Planning Appeal Online Observation

Online Reference
NPA-OBS-004100

Re: ABP – PL03.321285

In the townlands of Kilbane, Killeagy (Ryan), Shannaknock, Killeagy (Stritch), Killeagy (Goonan), Ballymoloney, Magherareagh and Lackareagh Beg, Co. Clare.

Figure 4-22b

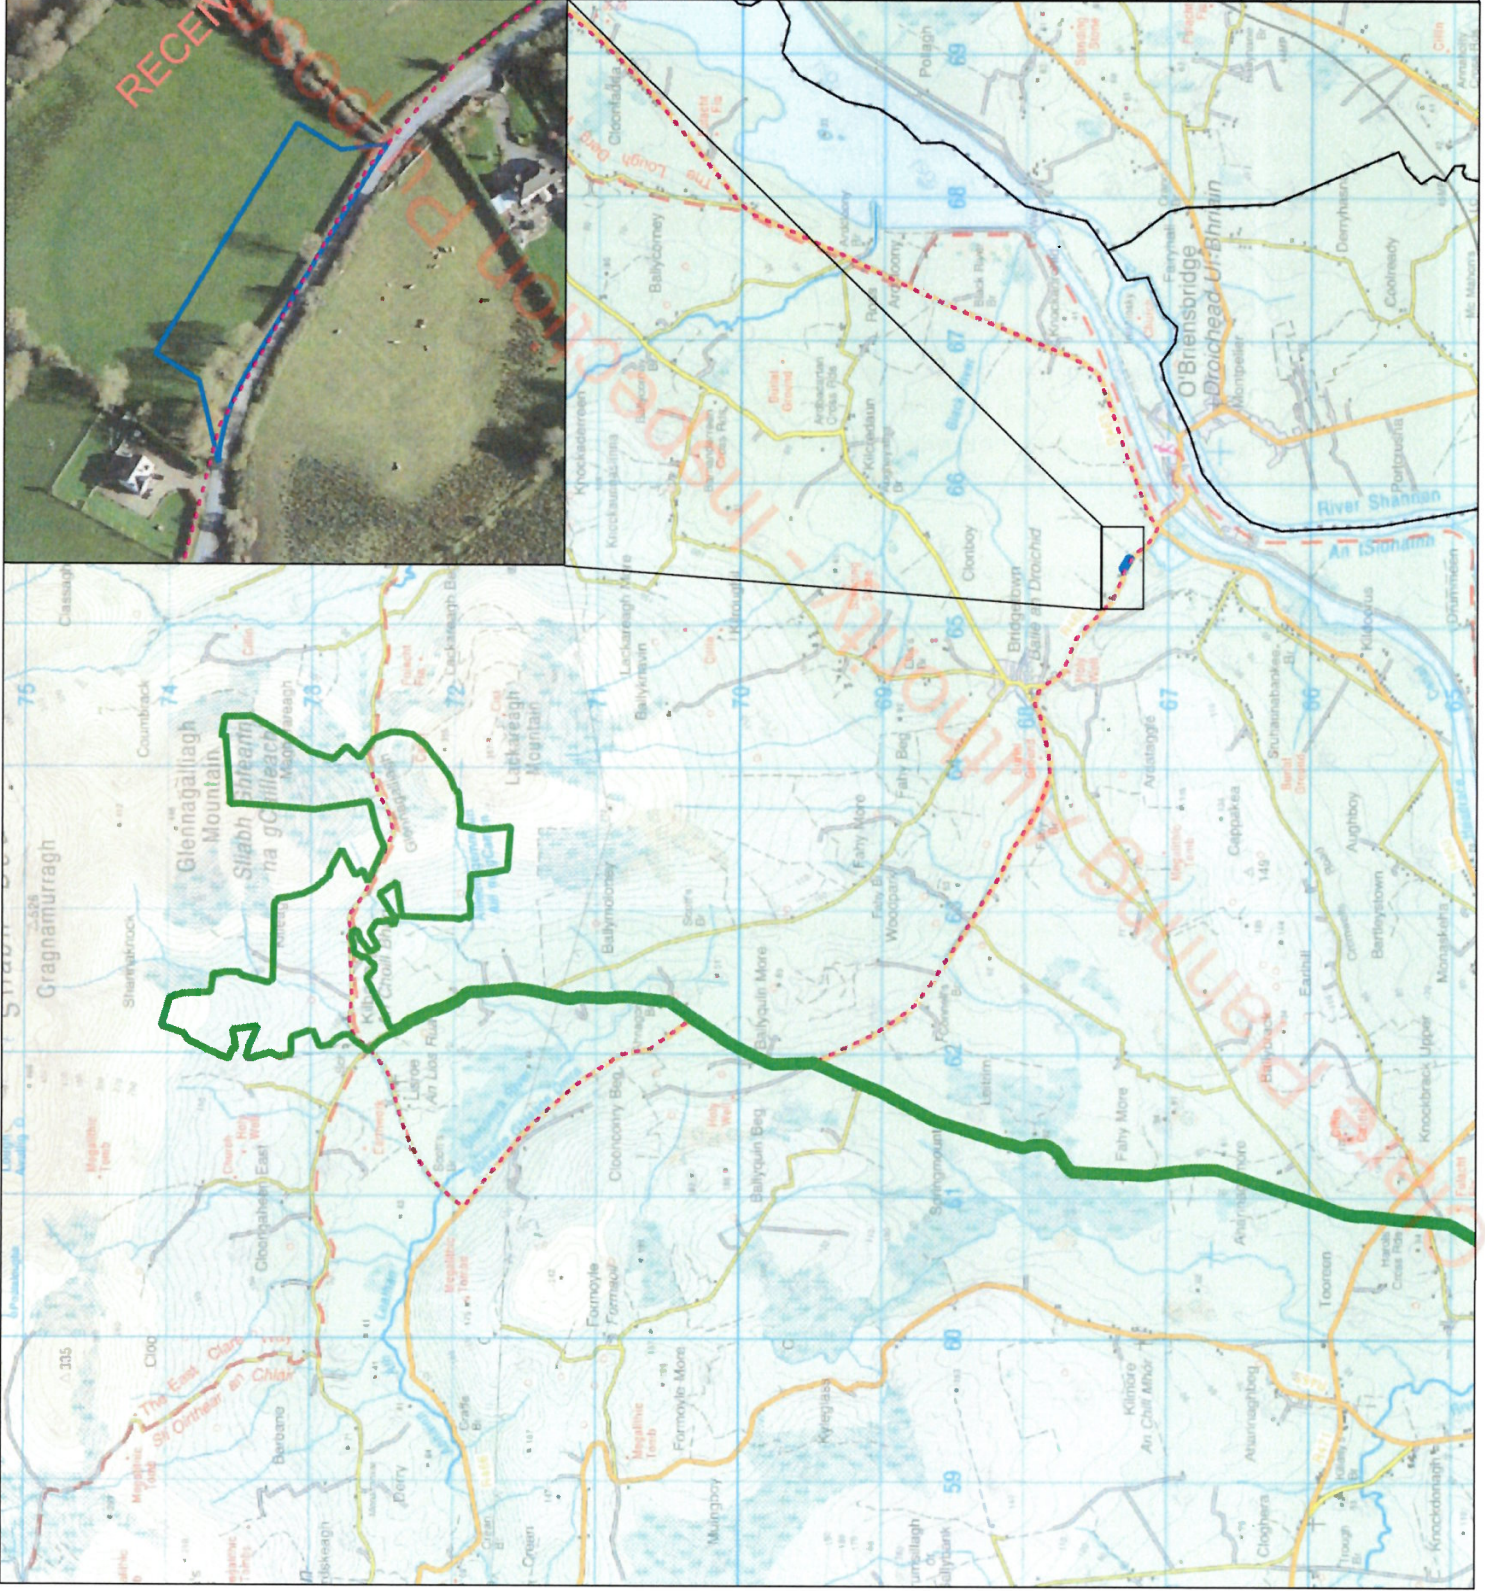
The EIAR is not coherent on the precise location of this blade transition area point (Location 9) throughout the report. Some parts of the report state its location is at the junction of the R463/R466. This is not the case. The location of the blade transition area is a field on the R466, as shown in Figure 4-22a and Figure 4-22b in chapter 4 of the EIAR.

Figure 4-22b has been attached for ease of reference below.

This image does not include the southern boundary with the roadside trees.

Plate 6.1: Photo showing receiving habitat along the proposed TDR (Accommodation Area: Proposed turbine blade transition area)

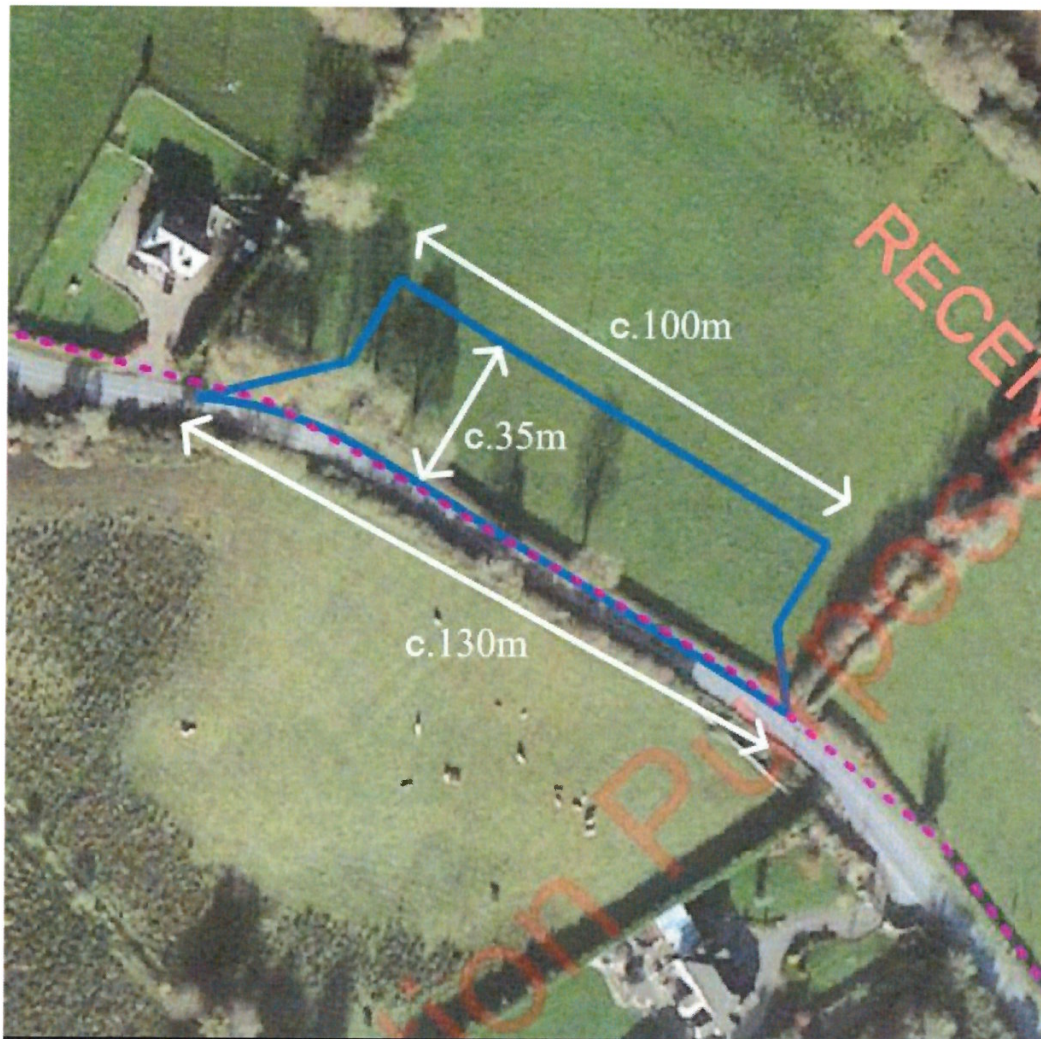
Apart from the image of Figure 4-22b referred to above, it appears the only image of the blade transition area supplied in the EIAR is the following image below:

This snippet below taken from 'Figure 15-2 Turbine delivery route autotrack assessment locations' shows the various alterations of a varying nature that need to be made along the R466 for this proposed development only. (Locations 9 -16.)

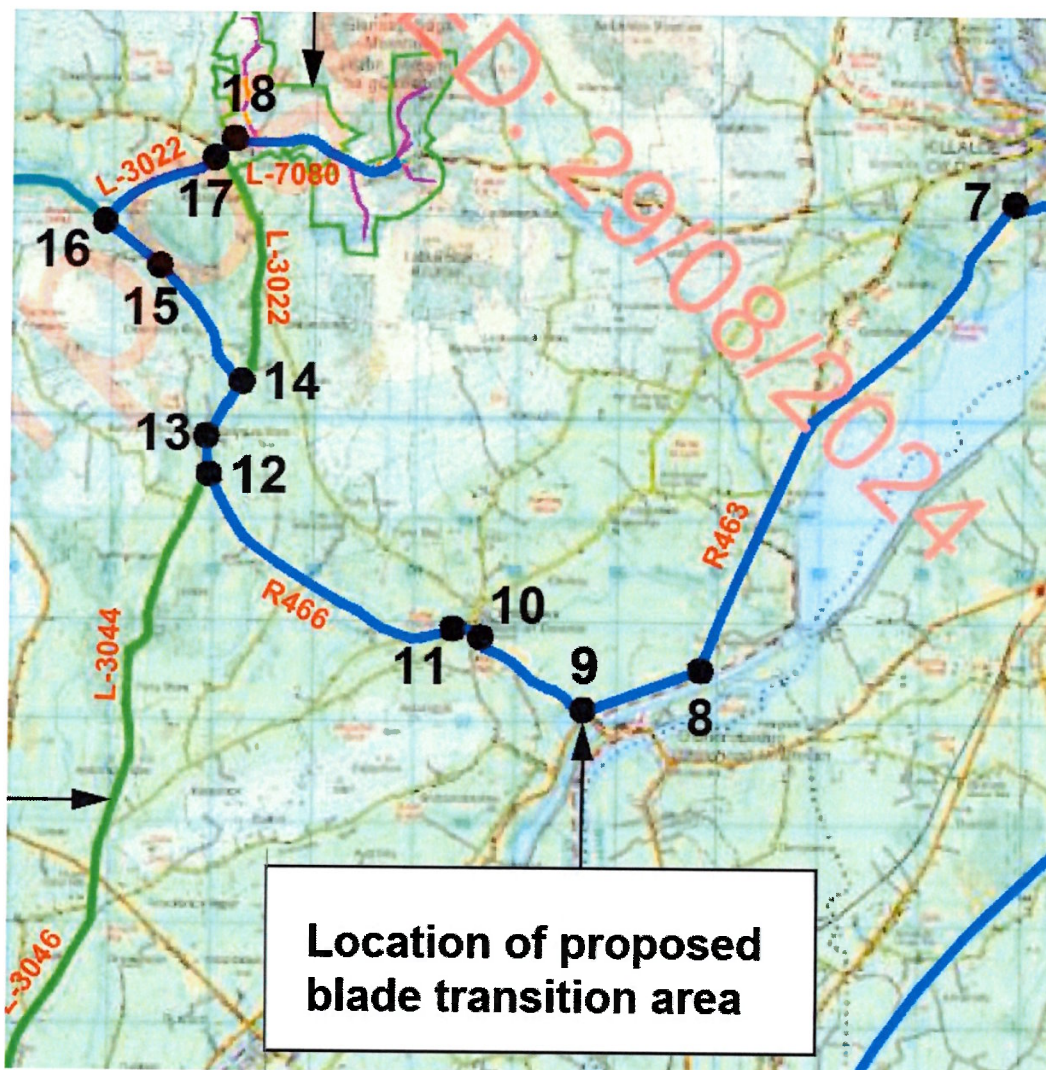
Fahybeg Windfarm and this proposed Windfarm are using the exact same turbine delivery route so why are we not given a cumulative analysis of the impact both these developments will have on the R466? The EIAR is incomplete as it does not fairly analyze the true impact this development individually and cumulatively with other windfarm developments, namely the Fahybeg Windfarm, will have on the R466 which is a designated scenic route by Clare County Council.

In addition to this, the cumulative impact of the multiple accommodation works for both Lackareagh Windfarm and Fahybeg Windfarm has the potential to fundamentally alter the characteristics of not only the village of Bridgetown, but also has the potential to fundamentally alter the characteristics of the designated scenic route R466 and contravene **CDP14.7**.

Snippet below taken from 'Fig 3-1 Survey Effort 2022' located in Appendix 6-2 Bat Survey Report:

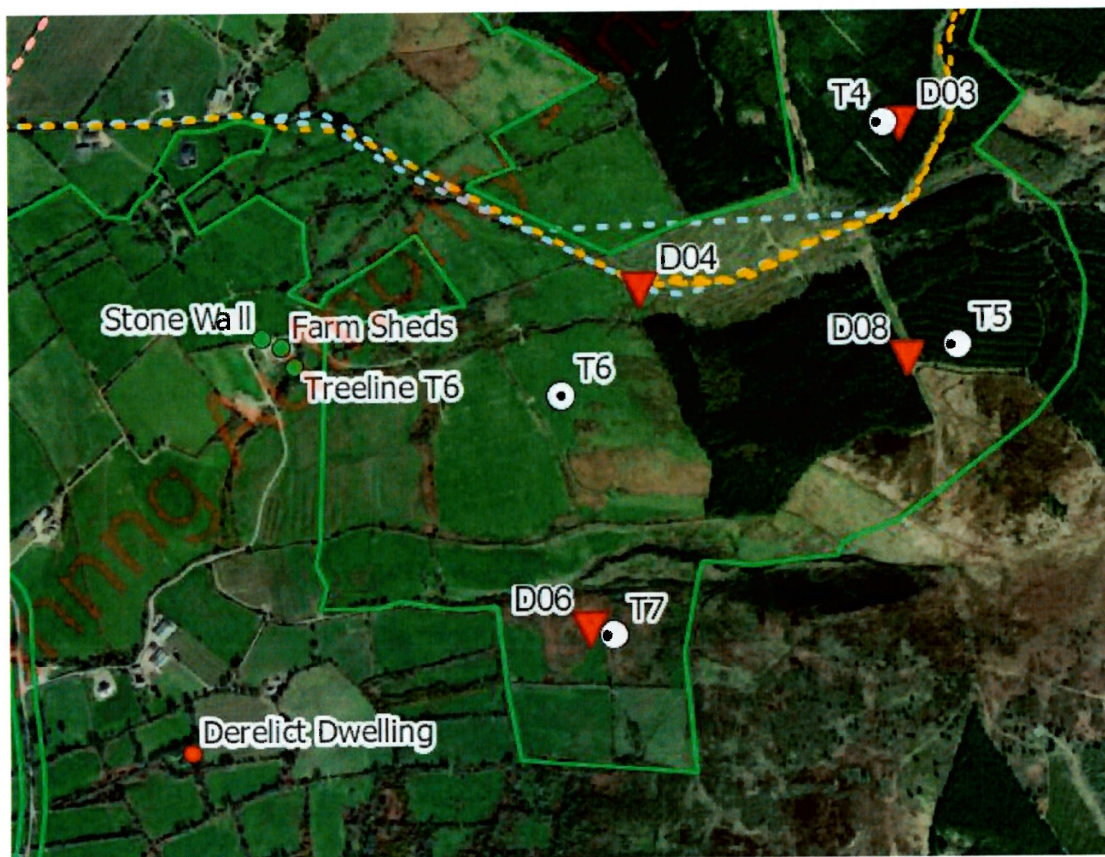
The foraging range of the lesser horseshoe bat is 2.5km. Turbine 6 is stated as being merely 710m away from this roost. Therefore, it is not correct to conclude that since the derelict house/dwelling is not located in proximity to any works it will not be affected by the proposed wind farm. Habitat areas within 2.5km of known roosts are important for supporting bat populations. We are not told

how far away the lesser horseshoe roost in the derelict dwelling is from Turbine 7 or any other turbines for that matter. Factoring in the location of the lesser horseshoe roost in the map below, it is highly probable that this lesser horseshoe roost is within foraging range of more than one turbine. Add to this the potential cumulative impact of Fahybeg Windfarm which is 250m away from the proposed windfarm at its closest point and this places this lesser horseshoe roost in a potentially precarious position.

The proposed development would have adverse effects on the foraging sites and commuting routes of the lesser horseshoe bat in this area. In addition, the lesser horseshoe bat is extremely sensitive to light pollution. It is submitted that the high intensity aircraft warning beacons that will illuminate these 7 turbines at night-time will also adversely affect the lesser horseshoe bat.

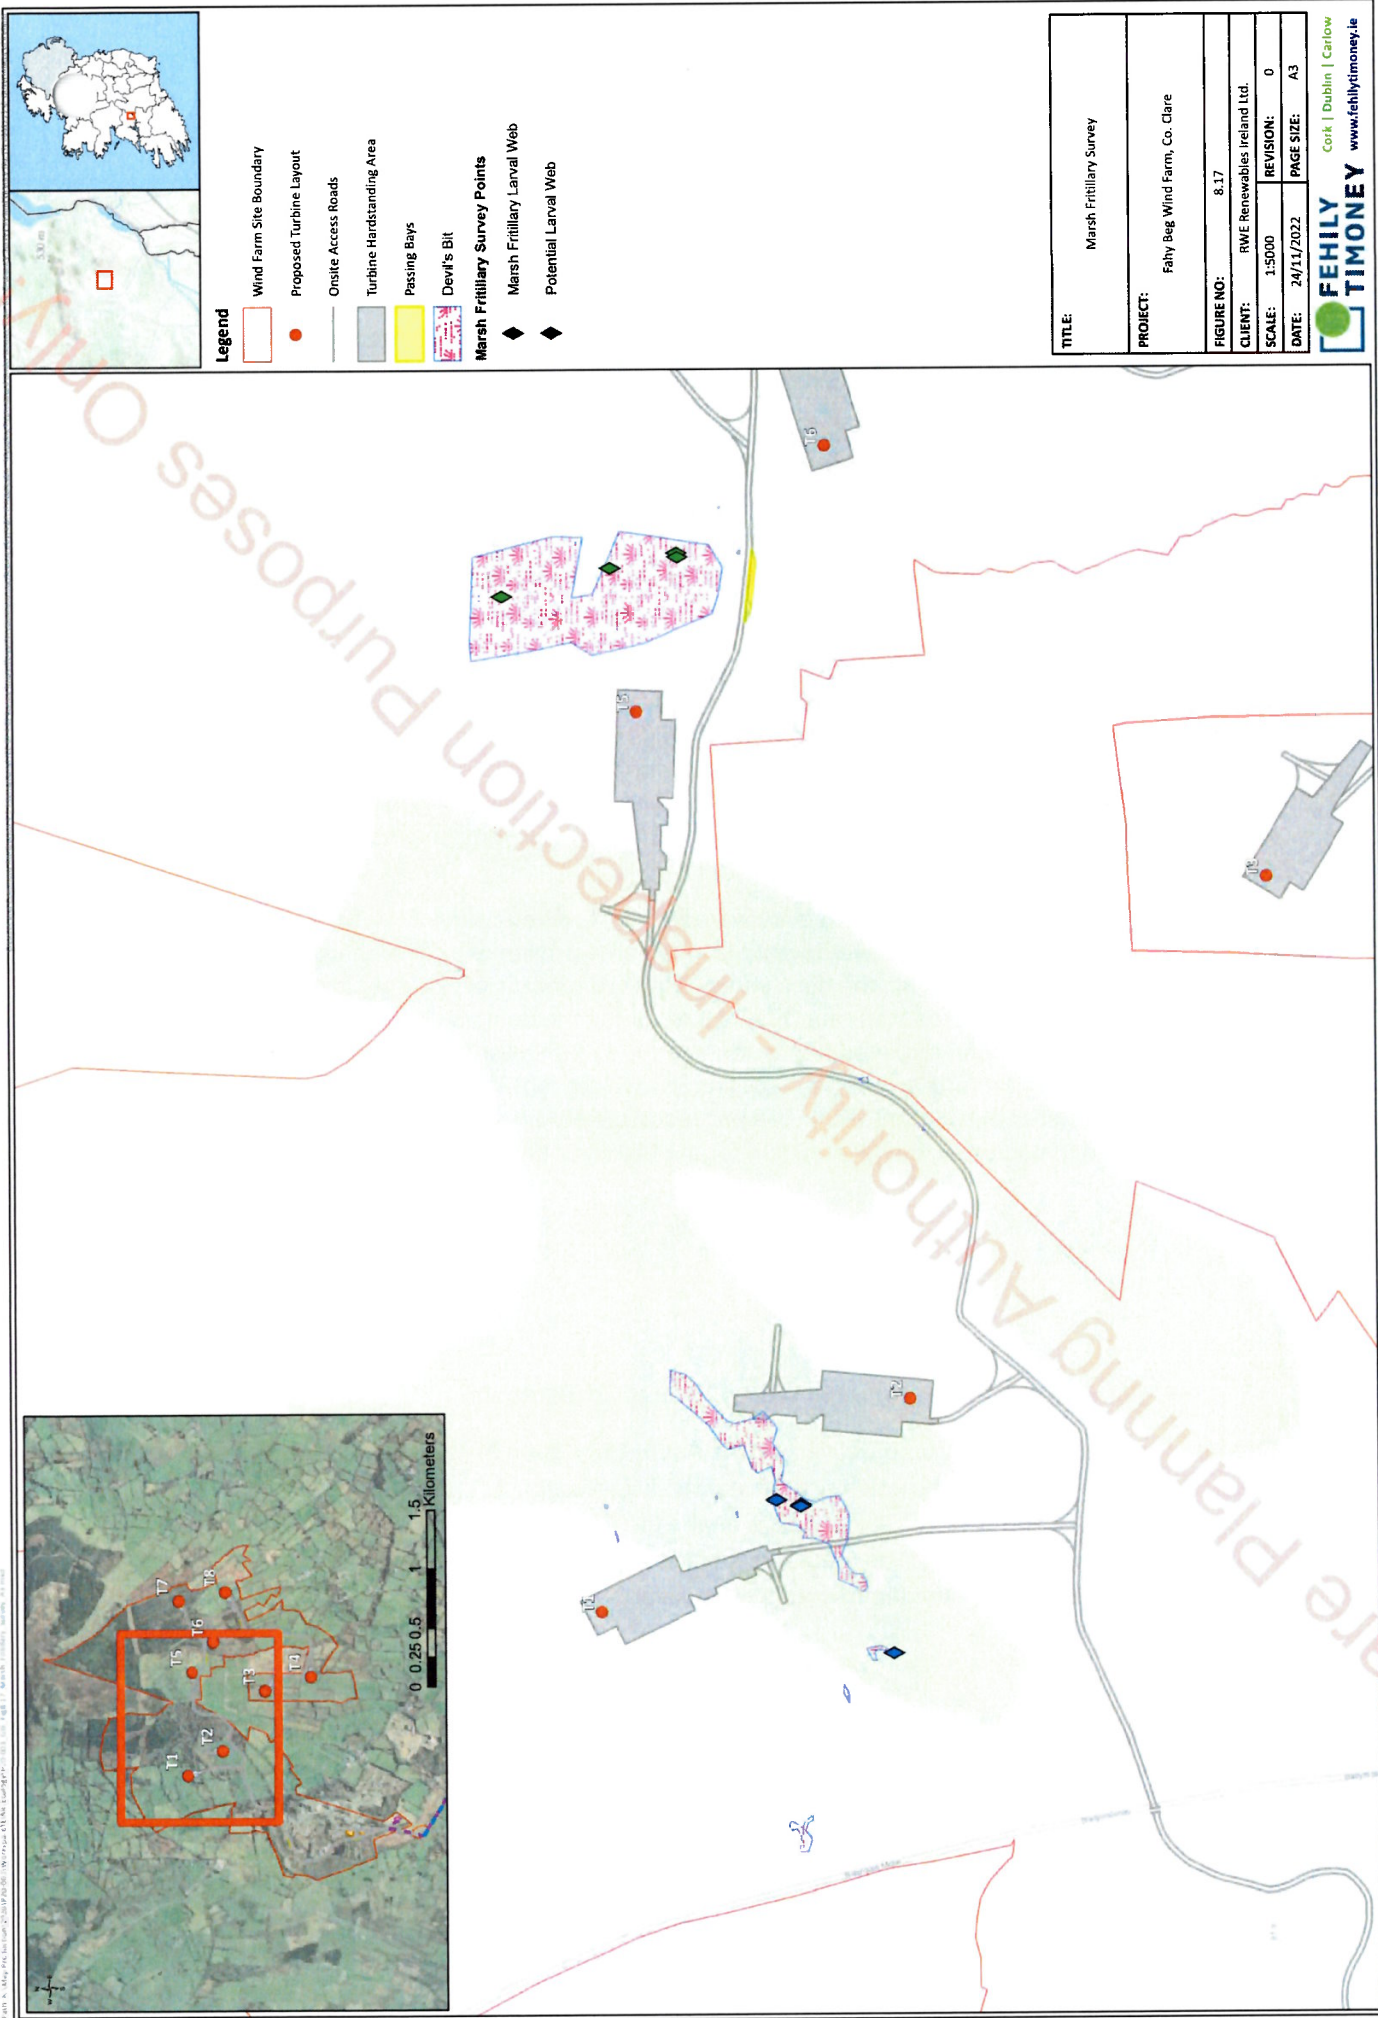
It is important to note however that a Marsh Fritillary survey was carried out from 19th -20th September 2022 by a neighbouring windfarm development, Fahybeg Windfarm. The results of this survey which were included in its planning application, found that there existed within that proposed development site sufficient density of devil’s bit scabious to support Marsh Fritillary. In addition to this, larval webs and potential larval webs were discovered. A diagram of these findings supplied in Fahybeg Windfarm EIAR and Marsh Fritillary Report has been included below for ease of reference.

Disappointingly, as stated above we are not furnished with the Marsh Fritillary Report in the EIAR or any diagrams of survey findings with regards to this species in this planning application. Instead, we are told that scatter areas of patches of devils bit scabious were discovered only, and no larval webs were recorded. Due to the extreme proximity of Lackareagh Windfarm and Fahybeg Windfarm, it is important however to consider the interesting characteristics of the Marsh Fritillary butterfly.
